The following Town Departments, Boards and Committees submitted comment letters to the Zoning Board of Appeals on the Thorndike Place Comprehensive Permit Application. Letters are attached in order.

**RE: Thorndike Place – Application for Comprehensive Permit**

RE: Arlington Land Realty, LLC Application for a Comprehensive Permit to develop  
Thorndike Place – Comments to the Zoning Board of Appeals

**Date:** Friday, September 23, 2016  
**To:** Laura Wiener; Planning & Community Development  
Ashley Maher; Zoning Board of Appeals  
**From:** Wayne Chouinard, Town Engineer  
**RE:** Plan review for Thorndike Place Comprehensive Permit

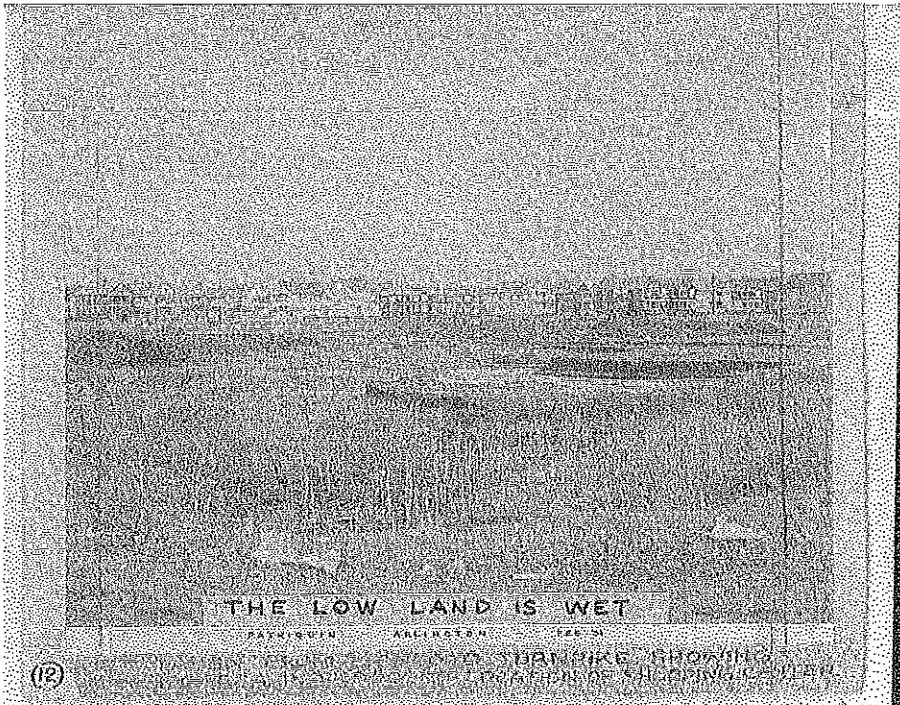
Plan sheet C-3.1 "Utilities" is marked with "Proposed Lake St. off ramp driveway access" and Sheet C.2.0, "Overall Site Plan", shows an access road directly off and onto Route 2 westbound, but it is not discussed in the project narrative. This possible access road appears to go through wetland resource areas and it is unlikely to be approved if it goes through BVW or isolated wetland.
